Design Report Addendum
Response to RFIs

Mixed-Use Development with Infill Affordable Housing
13–17 Oxford Street and 2 Verona Street, Paddington NSW 2021

Date	Purpose
SSD Reference:	SSD-87245208
DPHI Reference:	RFI-120198738 (3 May 2026) and Addendum (7 May 2026)
CoS Reference:	R/2025/23/A (5 May 2026)
Prepared by:	Tonkin Zulaikha Greer (TZG) Architects
On behalf of:	WT Malouf, care of 17 Oxford St Pty Ltd

Detail of Basement Level 2 Plan

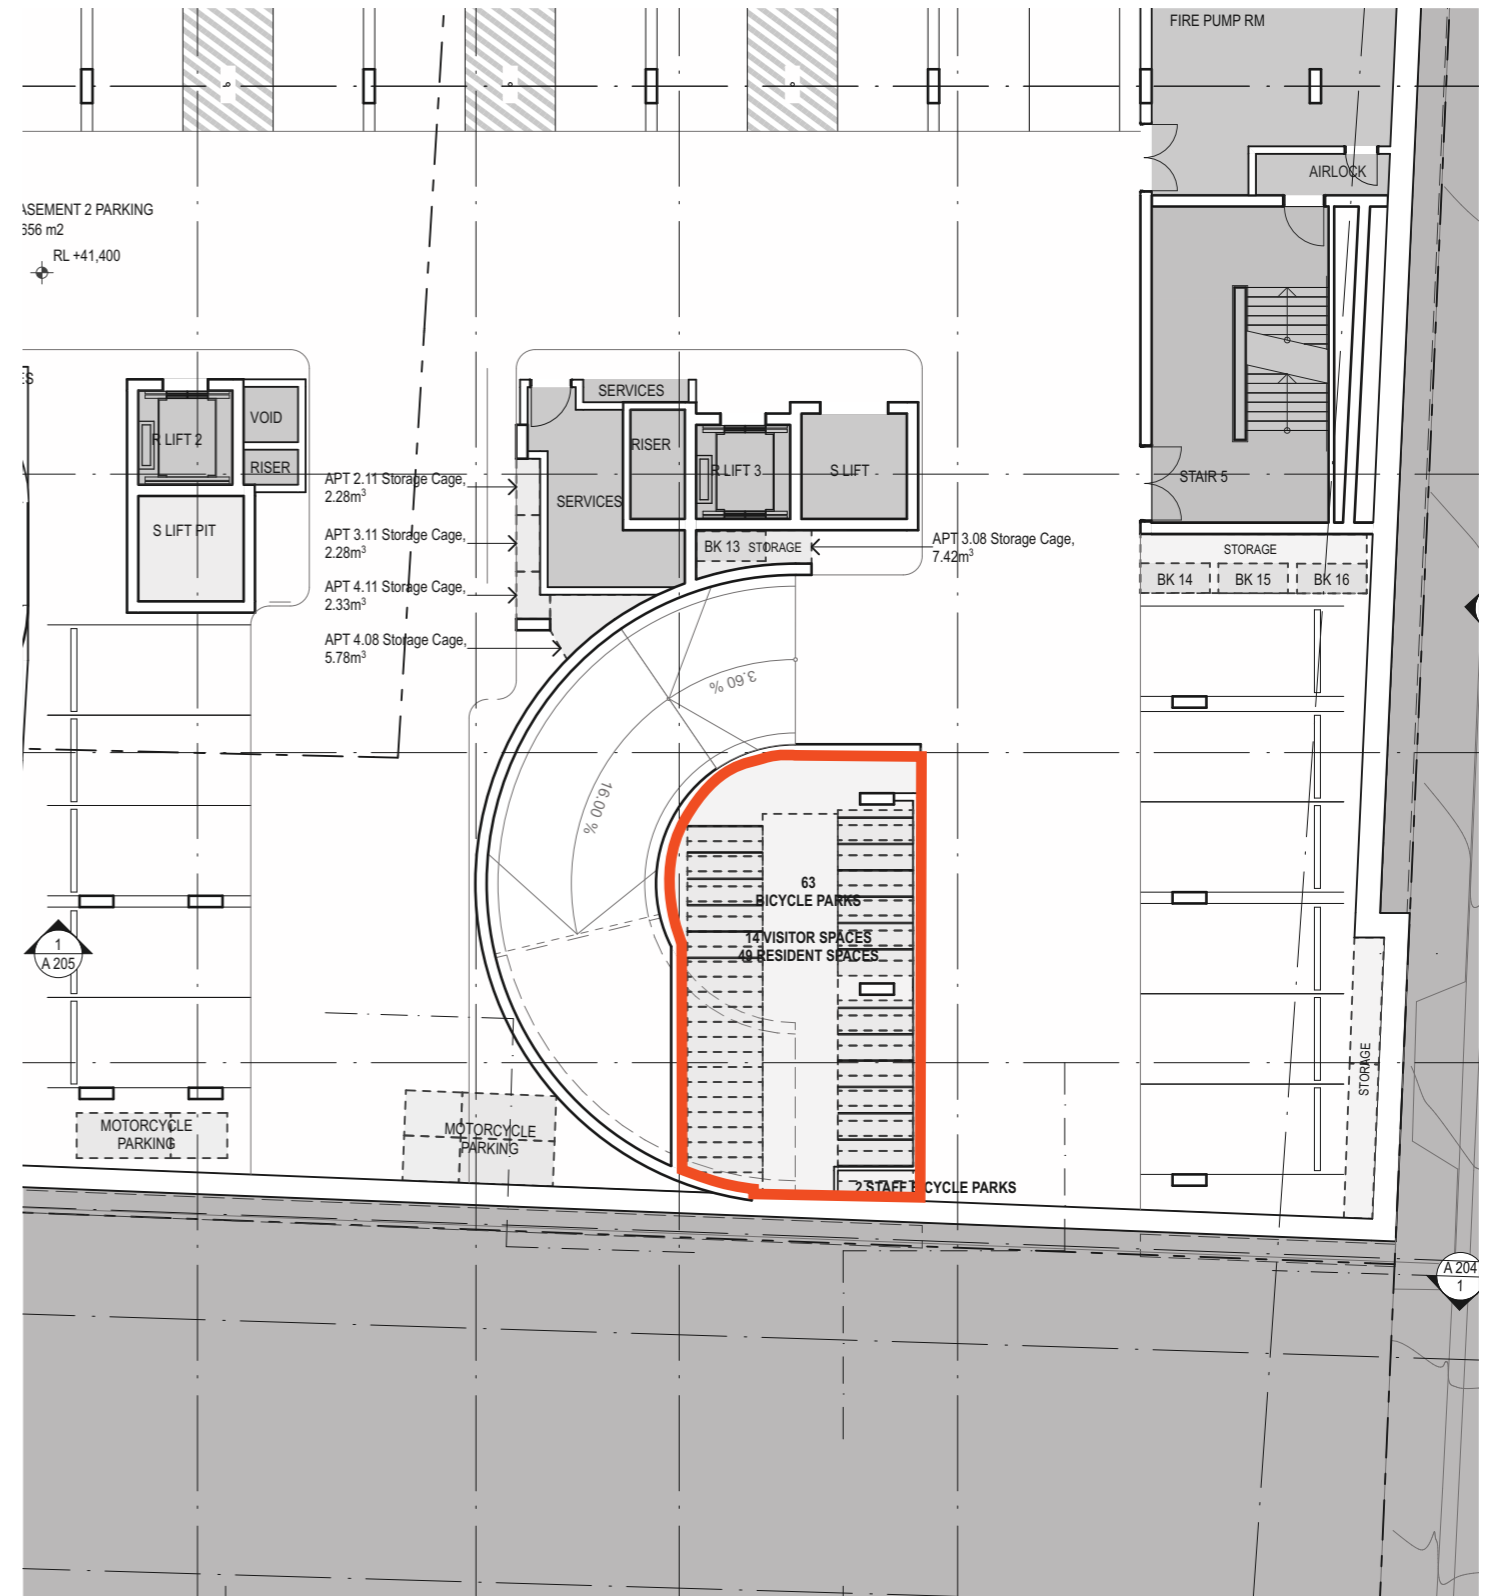
CoS Item 12.4 - Visitor Bicycle Parking	
Agency	City of Sydney
RFI No.	12.4
RFI Comment	<p>Visitor bicycle parking is to be accommodated on site and is not to be located in the public domain. The proposed approach to conditioning a Roads Act (section 138) approval is not supported.</p> <p>The proposed 14 visitor bicycle spaces are required to be located on the site. Given site constraints, locating visitor bicycle parking within the basement is acceptable to the City in this instance.</p>
Design Response	<p>TZG acknowledges the City's position that all 14 visitor bicycle spaces must be located on-site and not within the public domain. The amended design relocates the 14 visitor bicycle parks to Basement level 2 consolidated bicycle storage area.</p> <p>In order to facilitate the accommodation of 14 visitor bicycle parking spaces at basement level 2, amendments have been made to resident bicycle storage. Of the 65 bicycle storage spaces within the consolidated storage area on Basement 2, 49 are allocated to residents, 2 to staff, and 14 to visitors. The shortfall of 16 resident spaces is accommodated within the residential storage cages as numbered on the plans, each providing a clear internal dimension of 1,840mm x 800mm as confirmed by JMT Consulting.</p>

Detail of A 208 Section - Loading Dock and Terraces

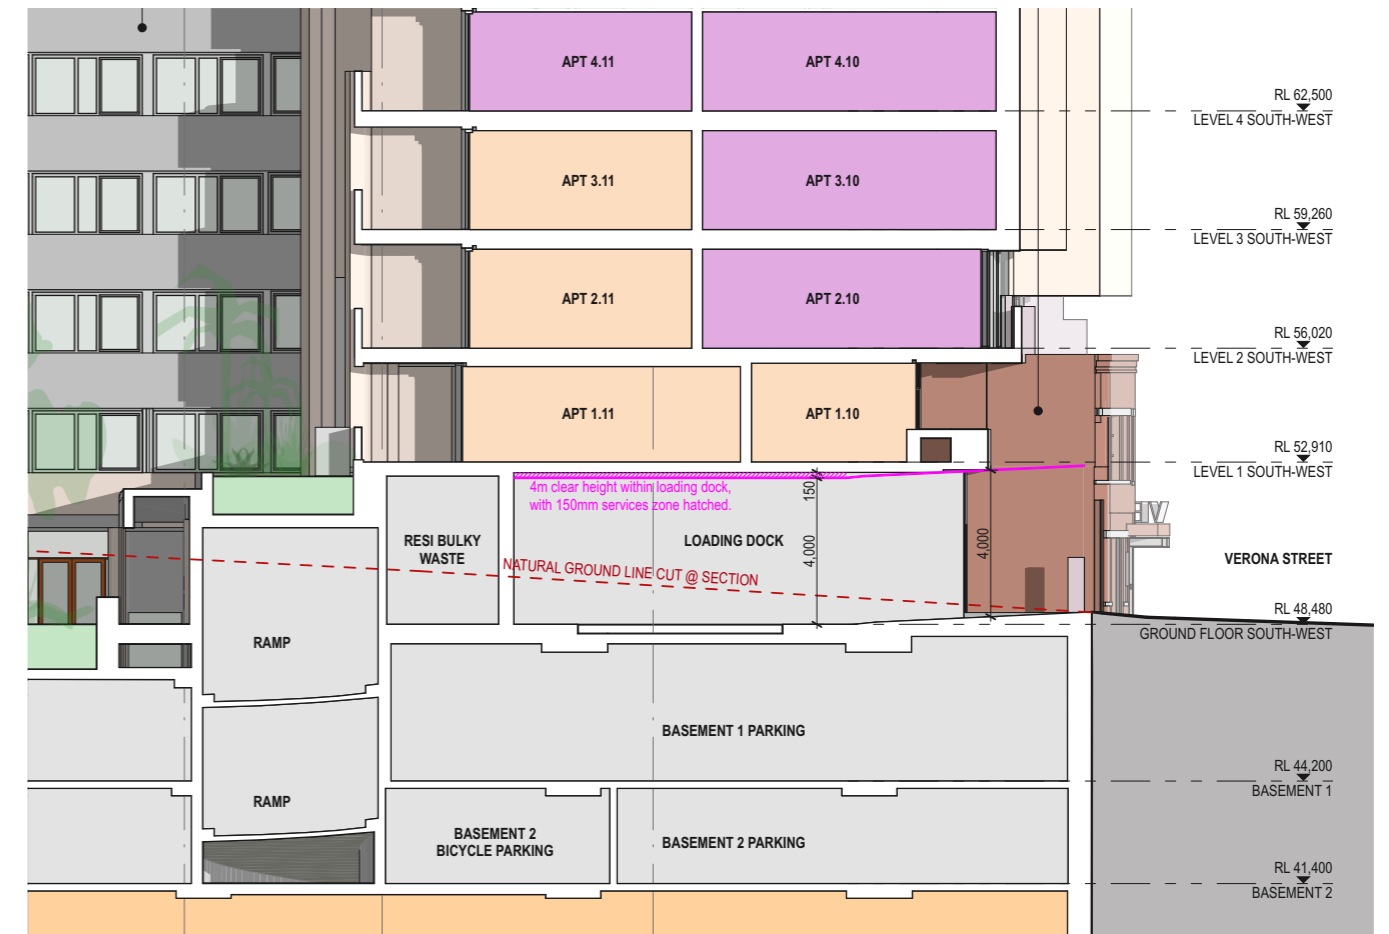
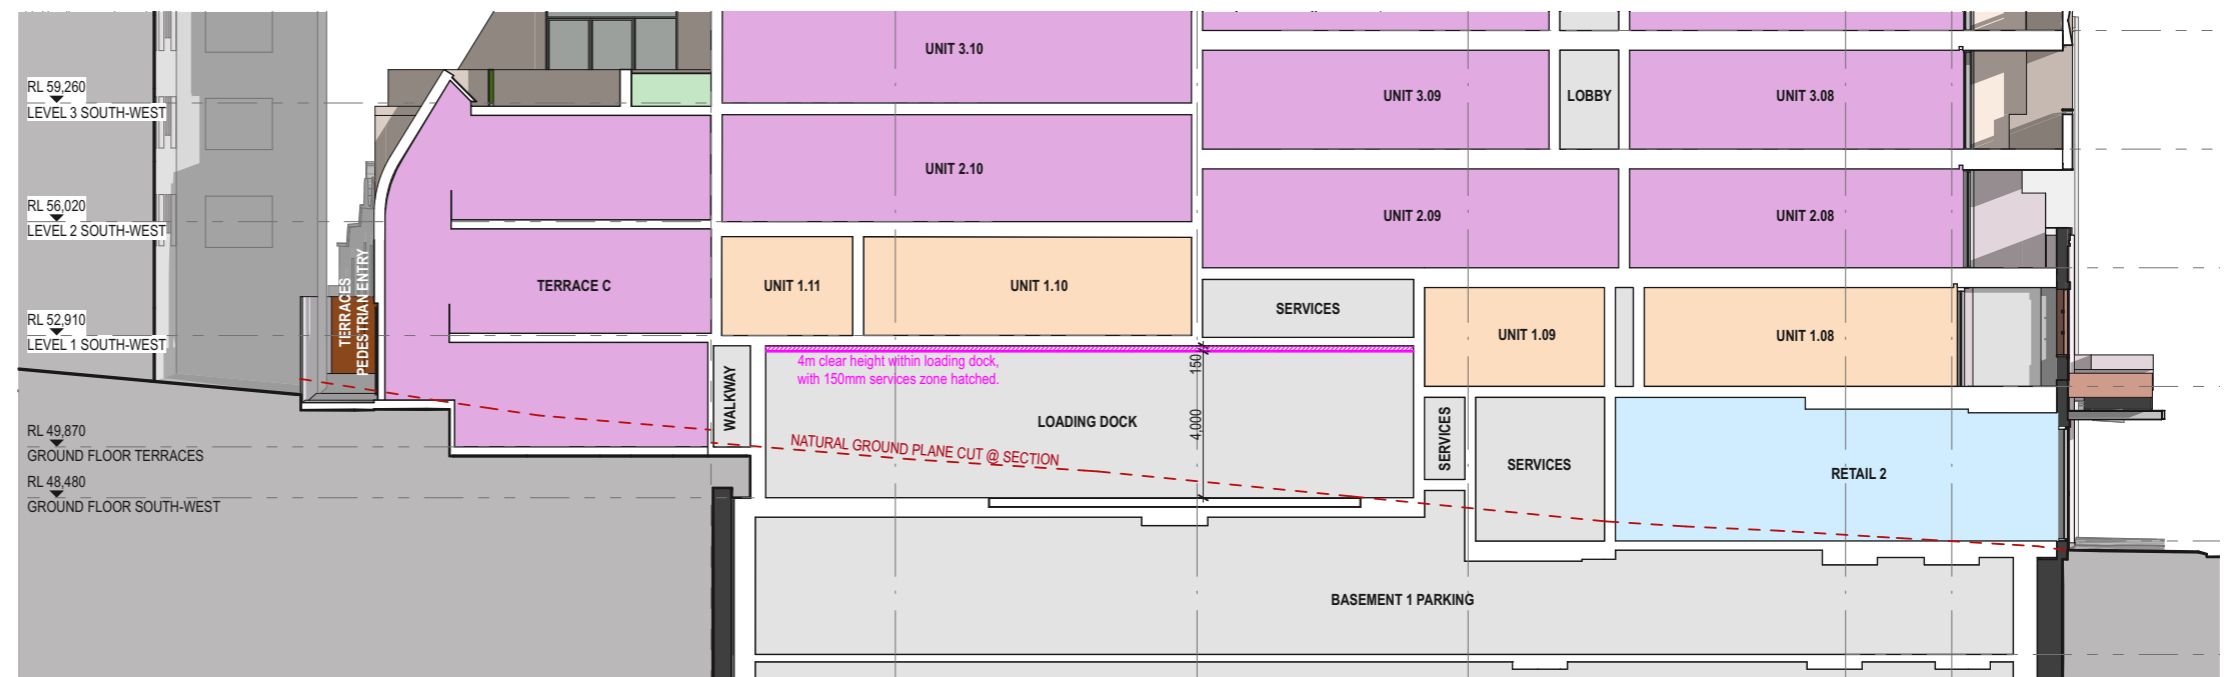
CoS Item 13.1 - Loading Dock	
Agency	City of Sydney
RFI No.	13.1
RFI Comment	No sections have been provided along the driveway between the loading dock and the adjacent road. Longitudinal sections through the driveway crossing are required to indicate adequate headroom clearance (4m) for the largest vehicle permitted to access the site (10.6m waste vehicle), in accordance with AS/NZS 2890.2.
Design Response	Longitudinal sections through the driveway crossing from Verona Street to the loading dock have previously been provided. The sections demonstrate that a minimum headroom clearance of 4m is achieved throughout the path of travel for a 10.6m waste vehicle in accordance with AS/NZS 2890.2. Structural blade walls have been incorporated into the Level 1 structural design in order to allow column-less, clear span structure for the loading dock on the Ground Floor. Refer to A205 and A208 as previously issued. Additional dimensions have been added to these drawings for clarity.

3D View from within Terrace C, looking toward courtyard, Level 2

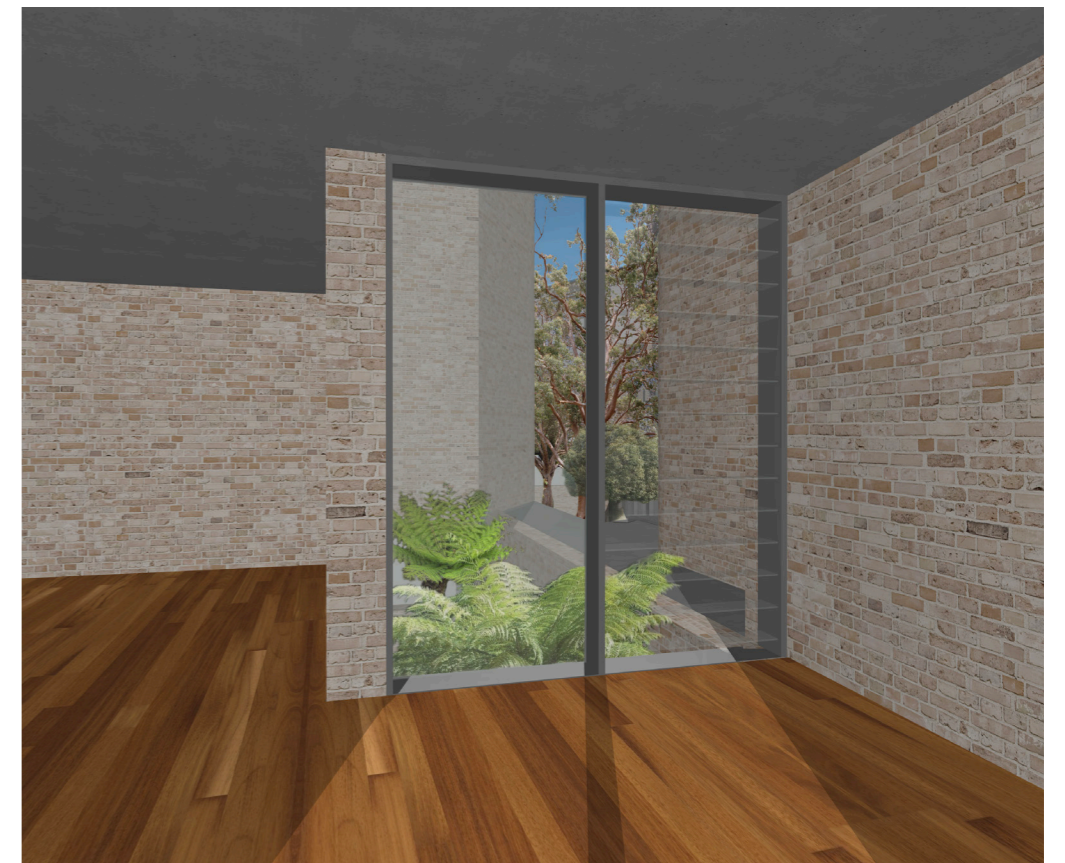
The field of view from Terrace C from within the bedroom and living space, including the extent of the outlook toward the courtyard and the sky exposure above the adjacent built form.

The effect of any reconfiguration to the balconies of apartments 2.10–4.10 on the perceived openness of the outlook from Terrace C.
